Witham Cycling Campaign

Objection to planning application <u>No 2000/1764/out</u> <u>800 houses Maltings lane</u>

(B) <u>North-South journeys</u>

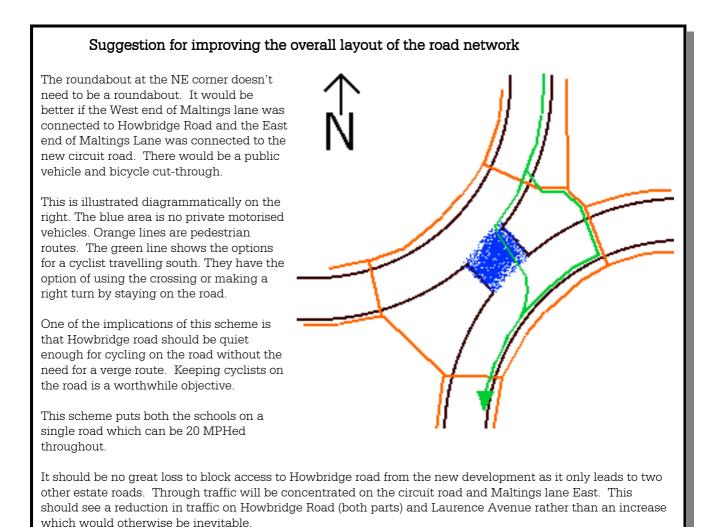
- The explosion of car journeys can be blunted if cycling is encouraged. To pretend that traffic on the two roads into Witham from the south will be tolerable without serious measures to reduce demand is a fantasy.
- The roundabout at the NE corner of the layout needs proper investigation for cycle friendliness. This is bound to be a busy node for cars, lorries and bikes. A recipe for disaster. *See next page*

A North-South path is shown on the plan. This should be properly constructed for non-stop cycling.

There is a small circular road which this path crosses towards the northern edge running south of Jackson's farm. We suggest that this route is severed so that the cycle path has complete right of way. This would then form (the southern part of) a major radial route.

- 2 The plan not be accepted without the main N-S route being non-vehicular and with right-of-way through the development.
- **3** County highways report on the comparative benefits of a roundabout and a noncross roads layout..

This layout and network would be safer than a roundabout for vulnerable road users.
